MANPRINT ASSESSMENT OF THE
HIGH MOBILITY MULTIPURPOSE WHEELED VEHICLE
HEAVY VARIANT (HMMWV-HV)
(Contract MDA903-83-C-0033)

March 1988

HIGH MOBILITY MULTIPURPOSE WHEELED VEHICLE HEAVY VARIANT (HMMWV-HV)

Figure 3.2.4. Sharp and abrading surfaces.

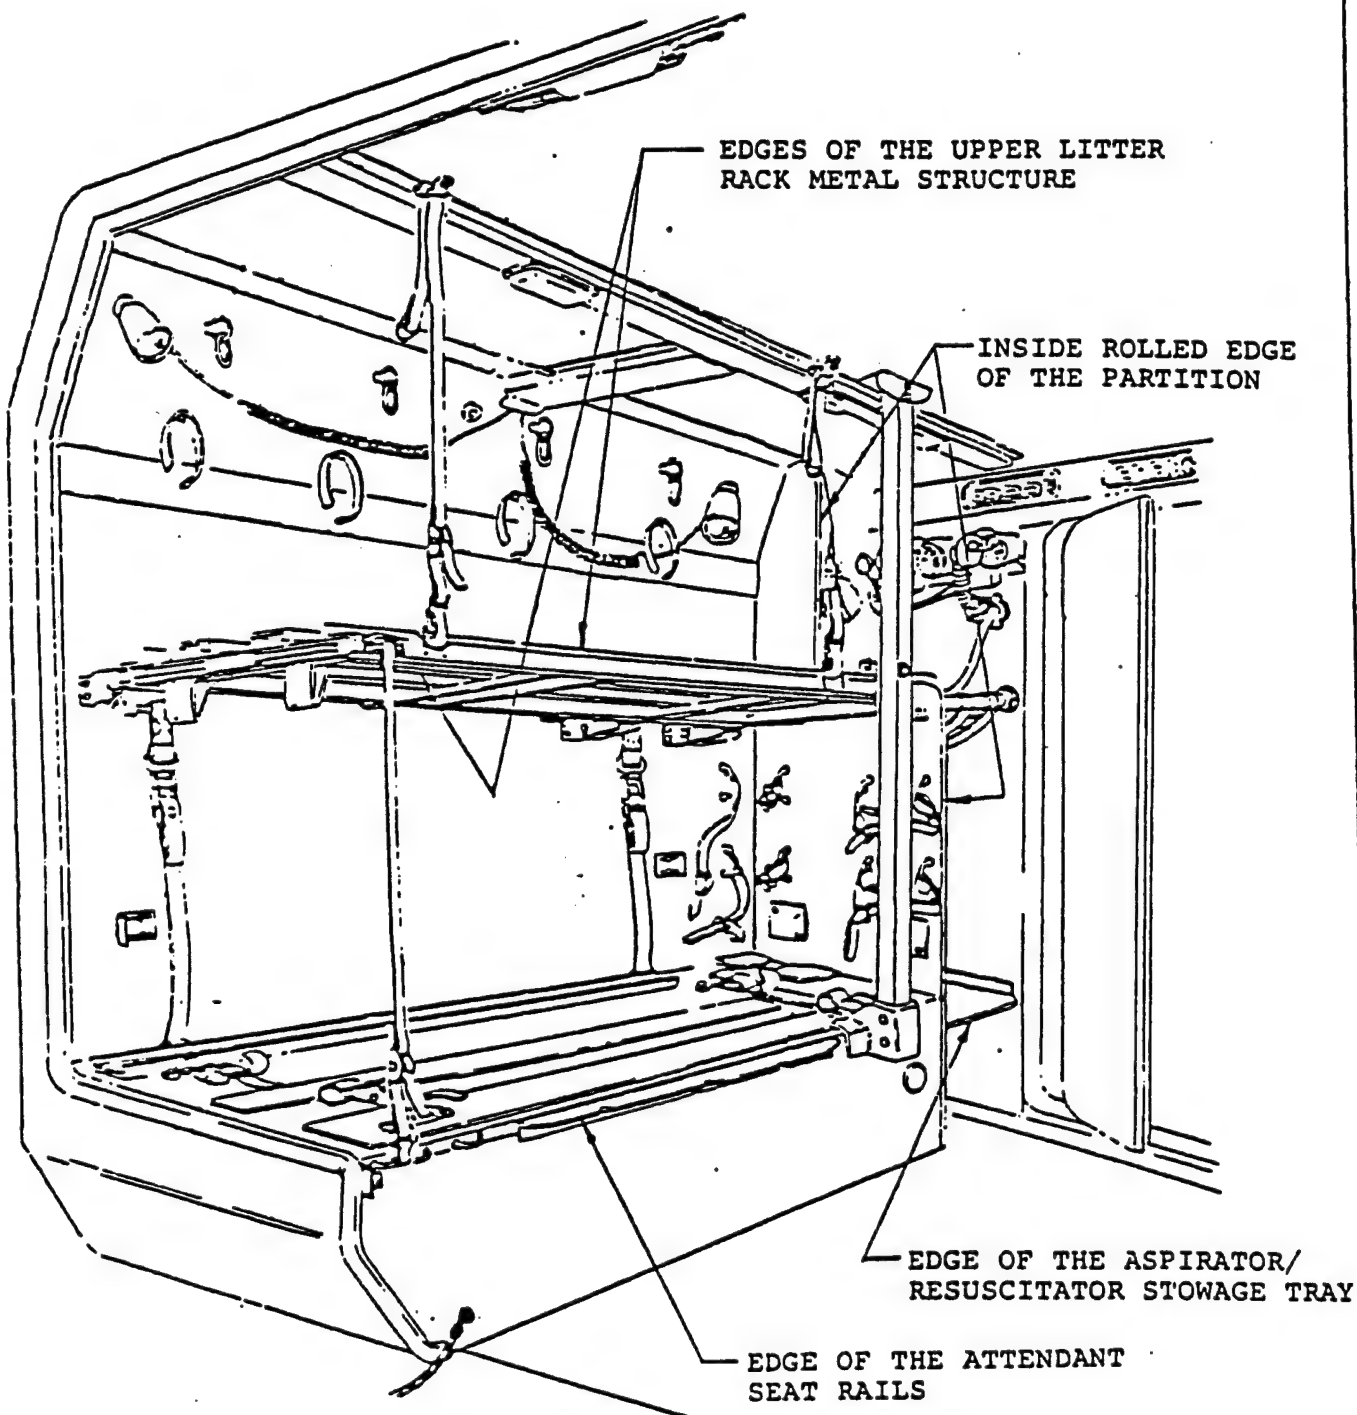
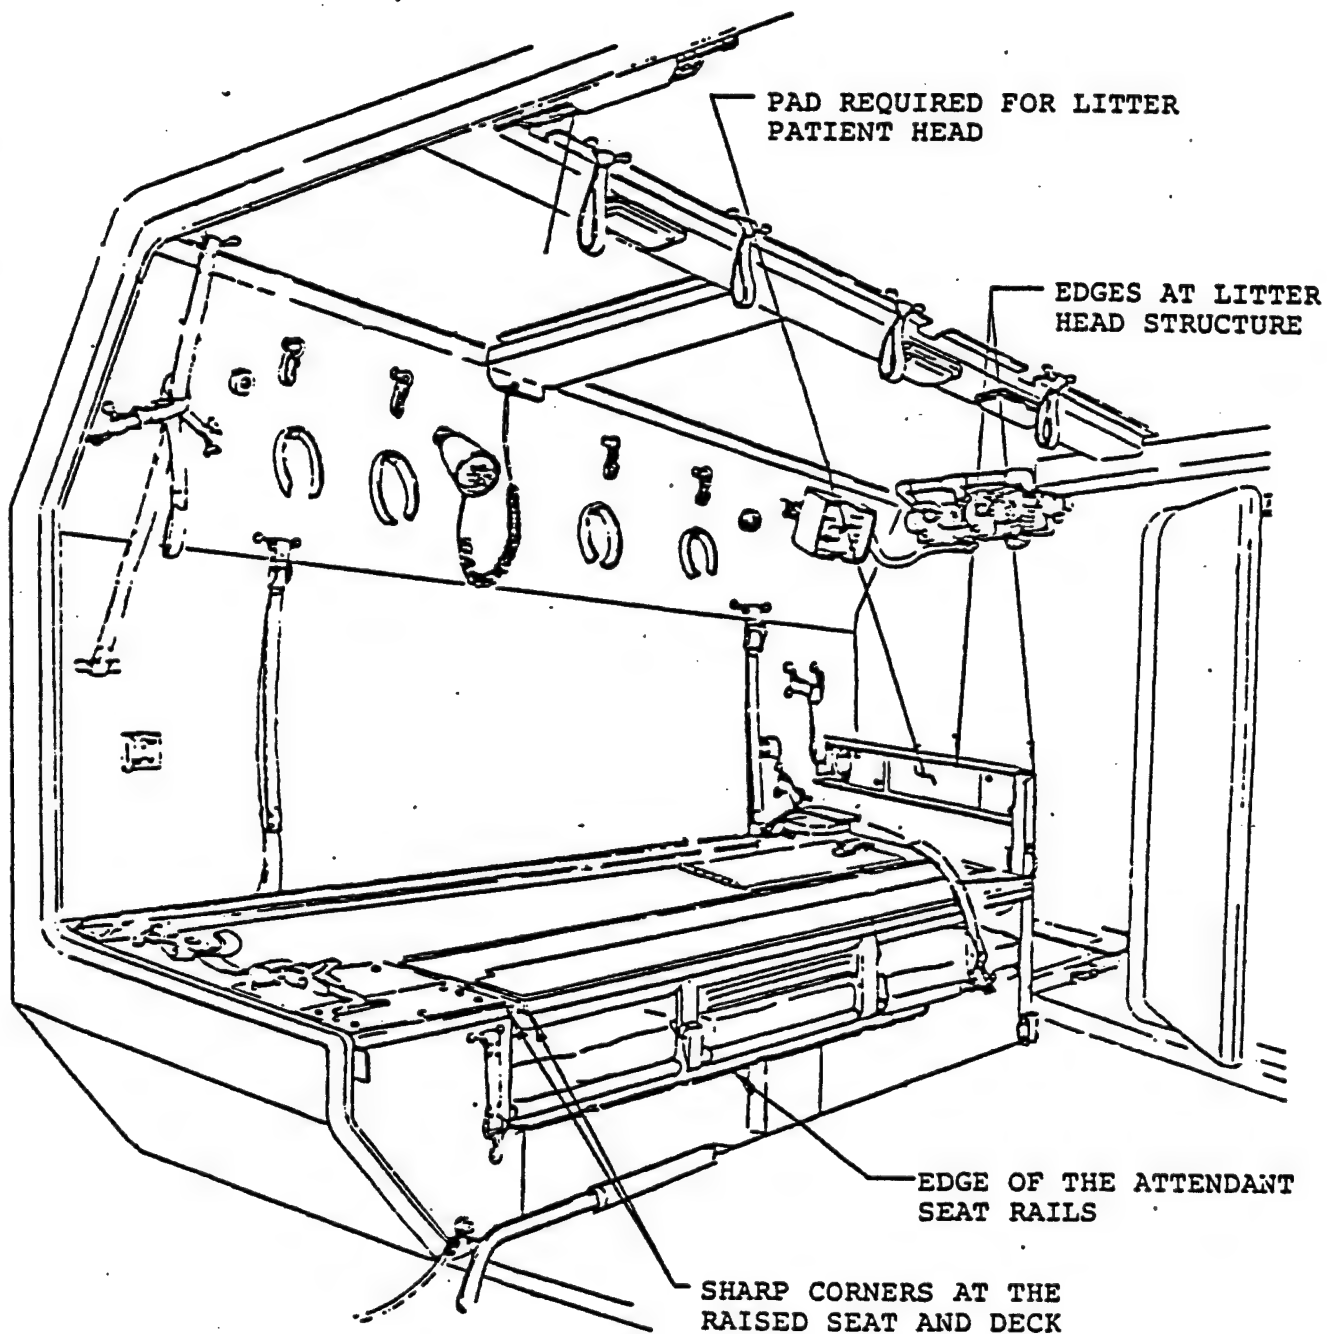
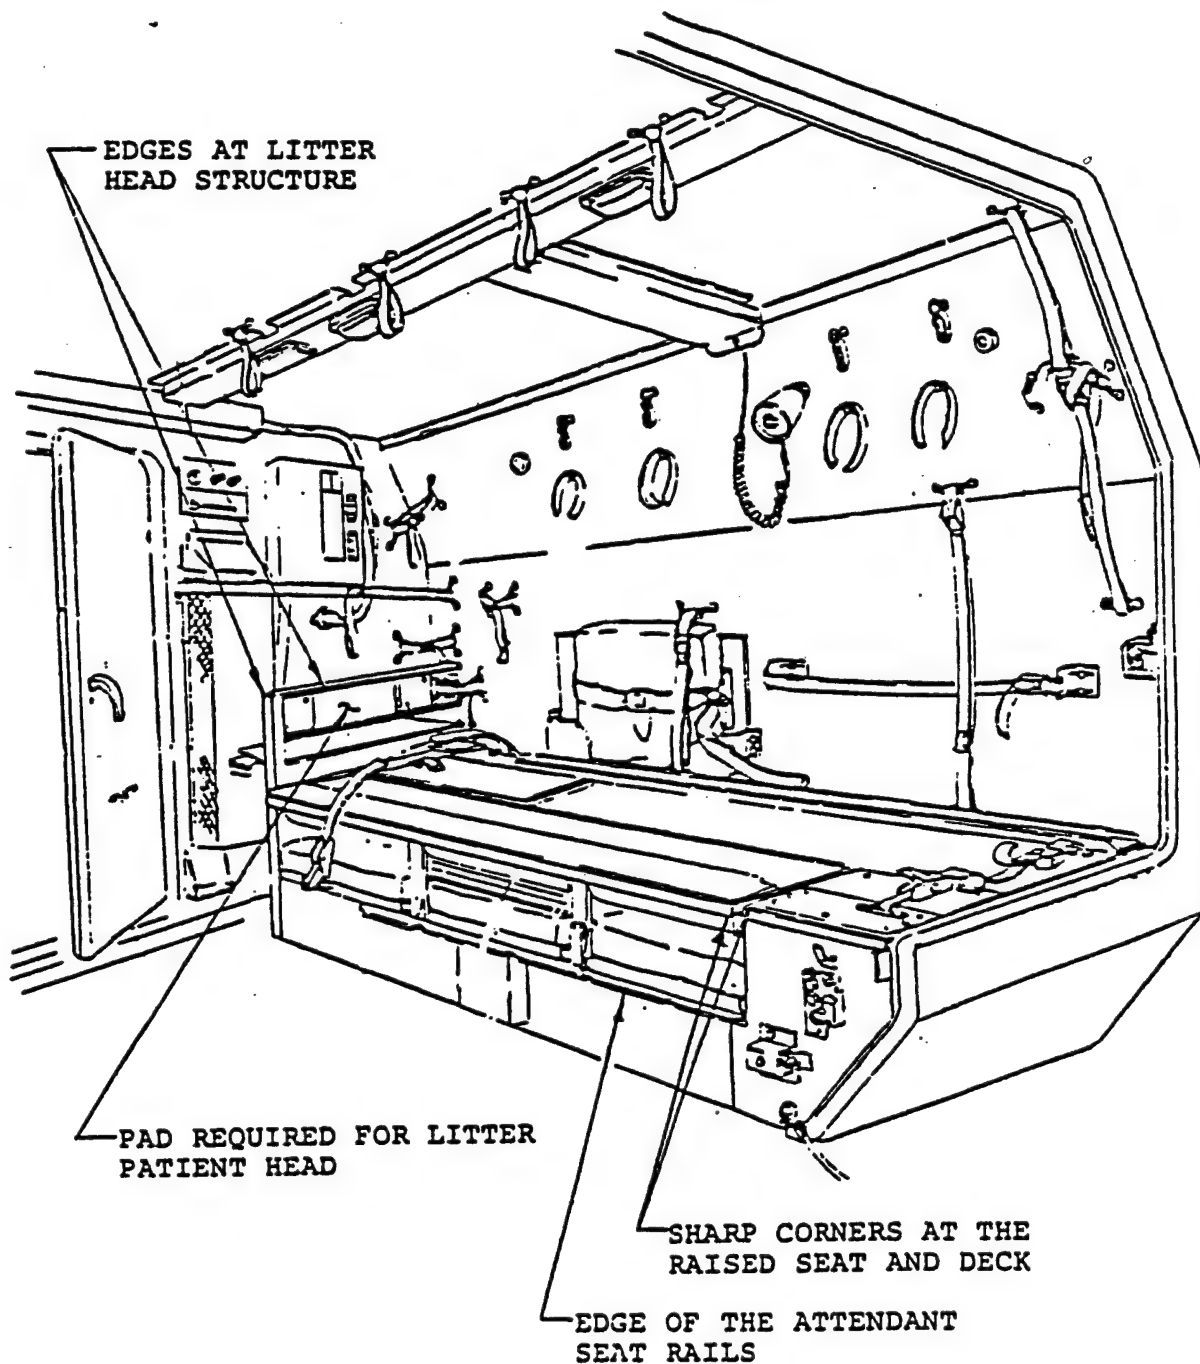
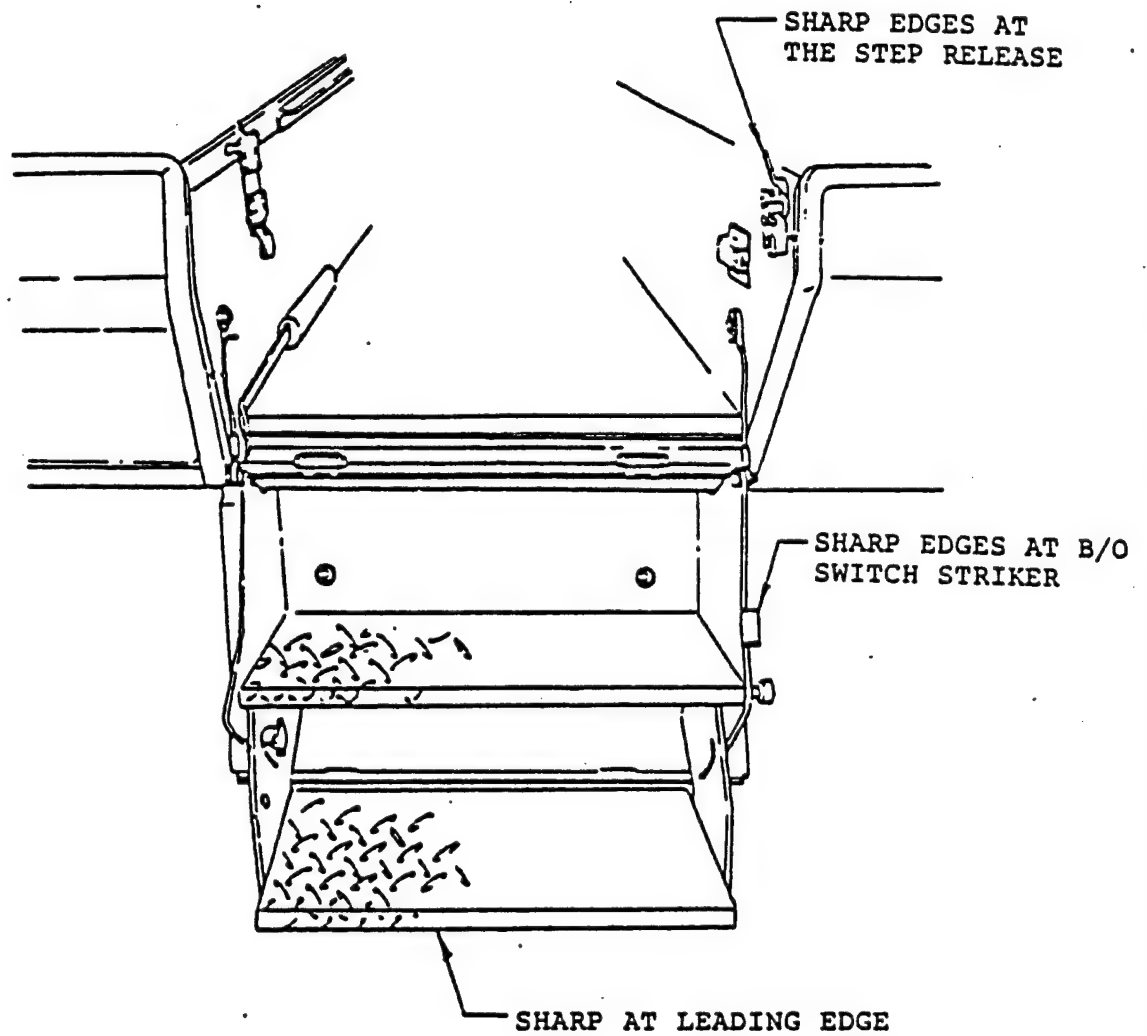
- 1) Litter ramp guide rails.
- 2) Edge located at attendant seat for retractable steps (see Figure 3.2.4).
- 3) Edges of attendant seat rails.
- 4) Edges of stowage brackets for aidman's seat.
- 5) Edges on step release lever.
- 6) Lower front corner of drivers and passengers door window frame.

Manufacturing processes that leave an unfinished edge and corners of equipment where projections are not padded or broken.

Sharp or abrupt edges and insufficient padding may result in injuries such as lacerations or contusions to operators and passengers. Insufficient padding leads to operator fatigue and reduced operator performance.

Roll all sheet steel edges. Radius or break all appropriate sharp corners. Add padding to surfaces as described.

DESCRIPTION
Figure 3.2.5. Aidman's sliding seat.

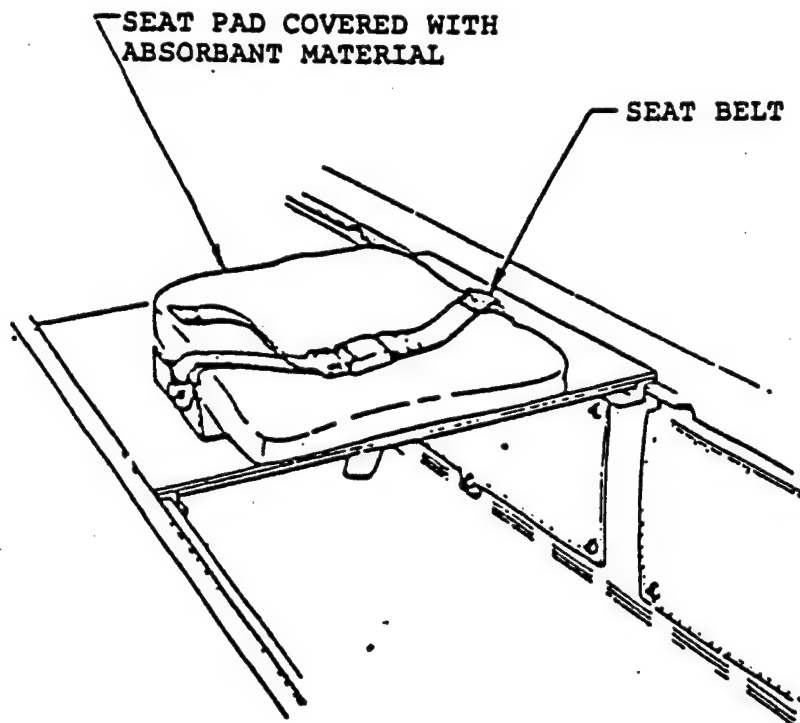
- a. The attendant seat cannot be locked into a position on its slide track so that the attendant can straddle the seat and work at a patient's head.
- b. Attendants are also pitched backward and out of the attendant's seat.
- c. Seat is covered with an absorbent material (see Figure 3.2.5).
- d. Aidmen cannot access the upper litter patient in the maxi-ambulance while secured to the aidman's seat.

a. Add additional detents into the seat slide track (especially one extra set of detents located directly between the two forward detent sets).

b. Incorporate a folding short lumbar support into the attendant's seat. The back of this folding support, when folded down, could be padded to allow the attendant to also straddle the seat. The folding back could be spring-loaded so the back would fold down when not in use to facilitate stepping over it.

c. Cover the seat with a heavy non-permeable vinyl covering.

Figure 3.2.6. Door latch handles.

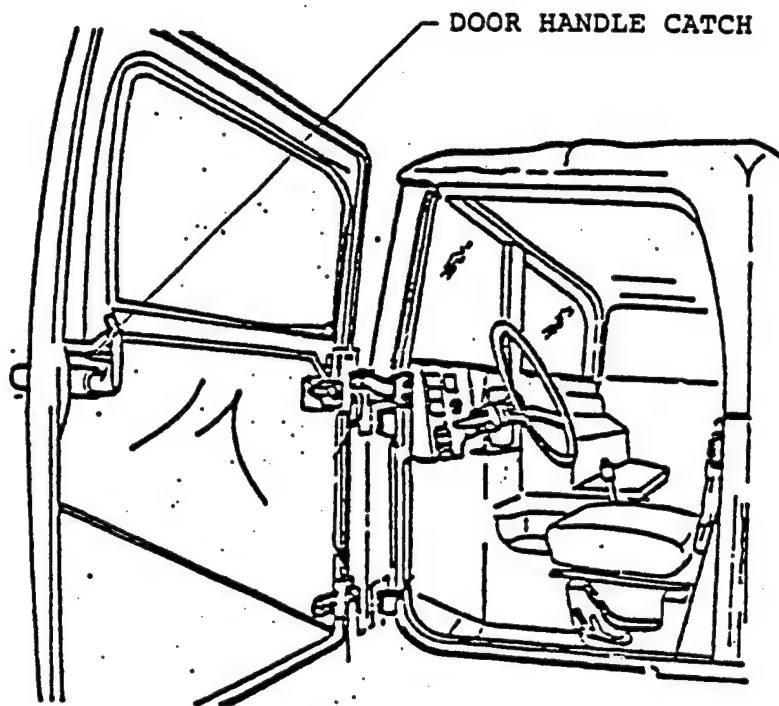
c. Door latch handles are prone to unlatching and are shown in Figure 3.2.6.

The poorly tensioned curtain allows the curtain to hit the crewmen in the back of their heads. Poor seals allow dust, cold drafts, and water to enter the crew cab. Doors have inadvertently opened during cross-country travel creating a distraction for the operator resulting in reduced vehicle control. The plastic windows defeat use of the side mirrors and reduce rearward vision.

Figure 3.2.7. Shelter carrier tailgate tripping hazards.

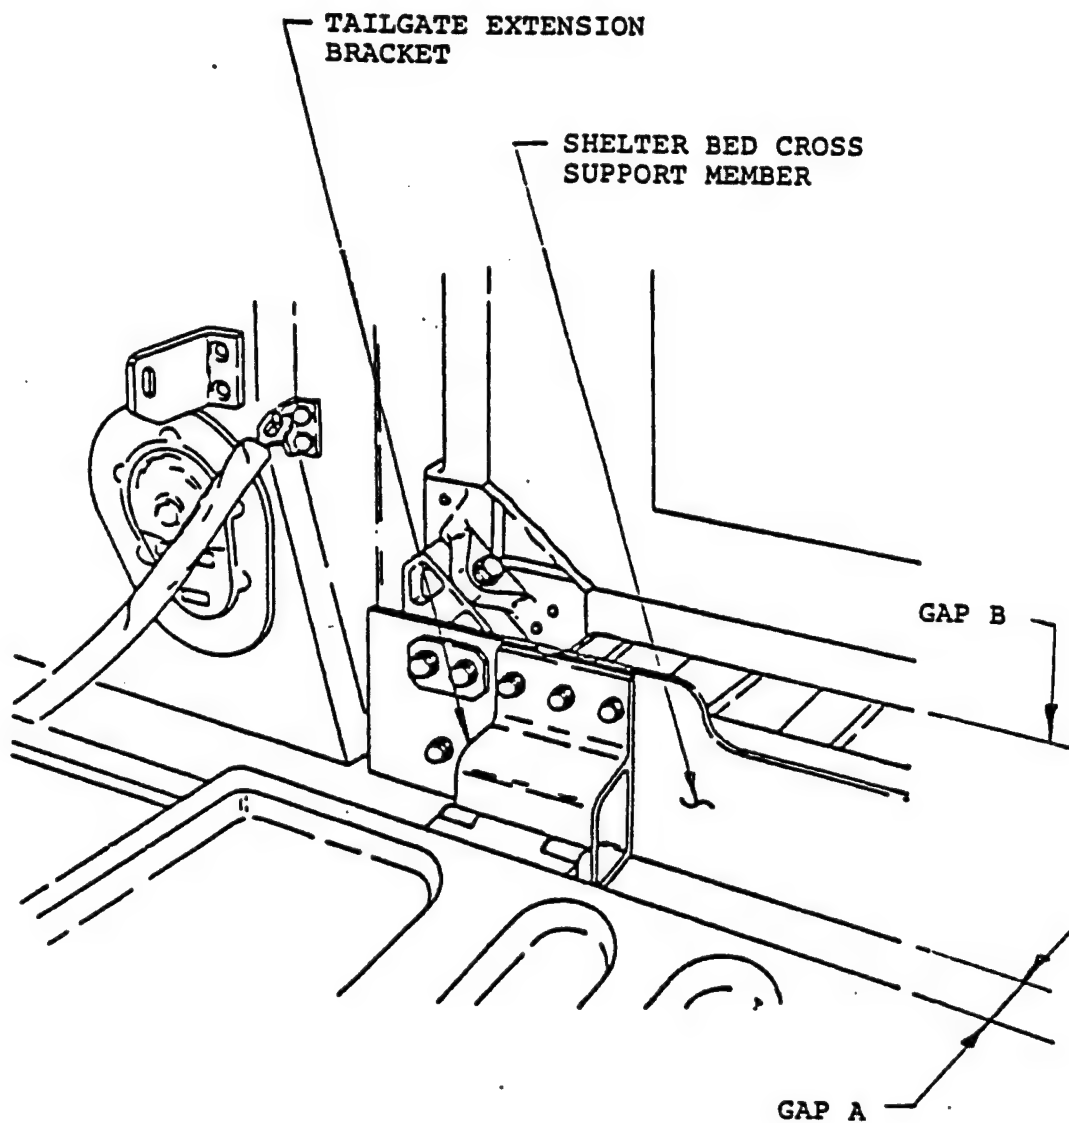
A tripping hazard exists for HMMWV-HV shelter carrier crewmen while entering or exiting the communications (S-250) shelter. There are two hazard locations shown in Figure 3.2.7:

a. The tailgate gap is large enough that a soldier's boot could lodge in the opening. A soldier when exiting the shelter and with his boot pinned in the gap could fall from the tailgate to the ground. Severe injury may occur to the soldier's pinned foot during such a fall.

b. A soldier's boot can become lodged between the unlifted shelter and vehicle bed. This may occur while a soldier is entering the shelter causing him to trip resulting in injury.

Add a horizontal plate attached to the shelter bed cross support member to fill the gap between the cross support member and the tailgate. This plate would be fitted to the cross support member.

Figure 3.3.1. Driver's seat adjustment slot.

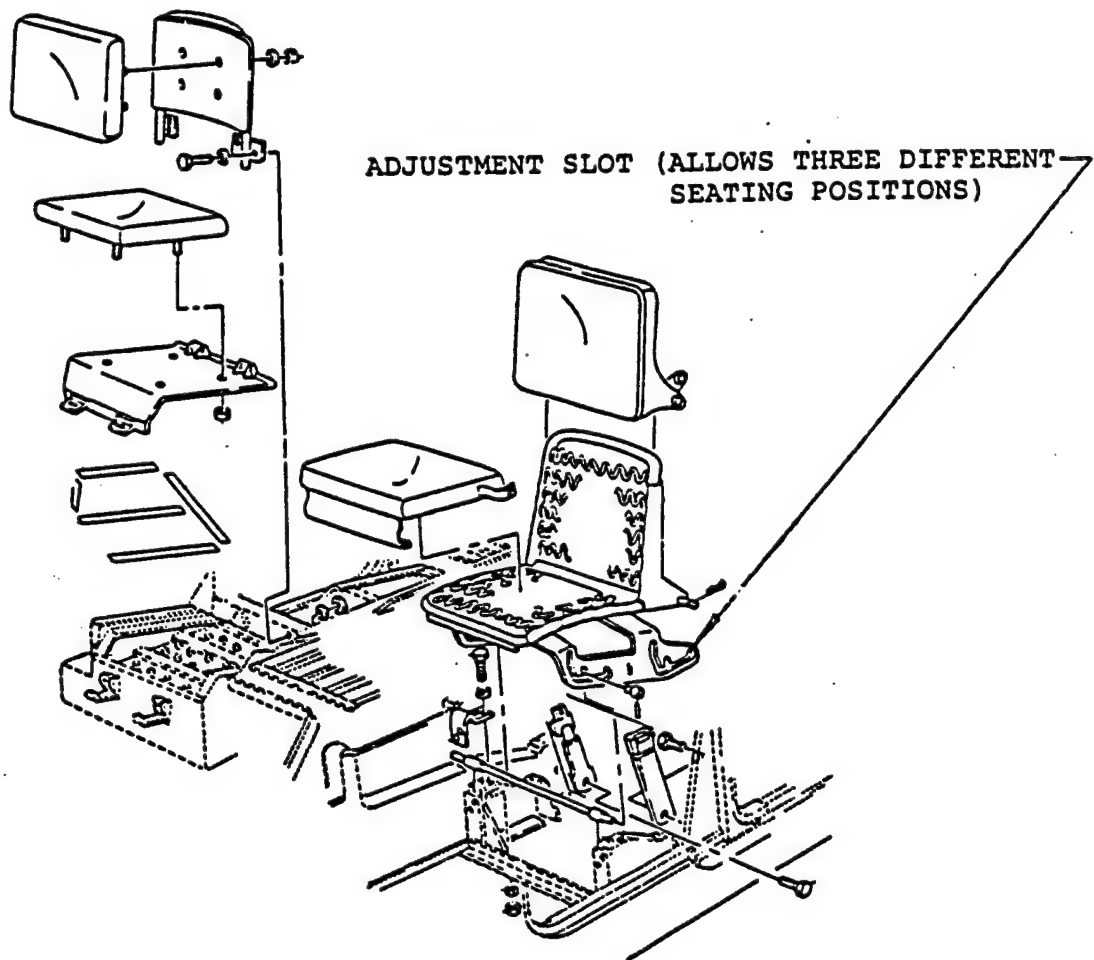
a. The width of the HMMWV and non-sloping hood reduce the driver's visibility to see critical frontal areas of the vehicle. The lack of driver's seat adjustment locations contribute to this problem and also leave many drivers with insufficient leg room. The three available seat adjustment positions are shown in Figure 3.3.1. Interviews with drivers have provided the following:

c. Operators increase height by adding or packing gear below driver's seat pad:

- 1) Improper use of equipment leads to unstable seating position.
- 2) Reduces the effectiveness of the seat belt.

Redesign driver's seat to either:
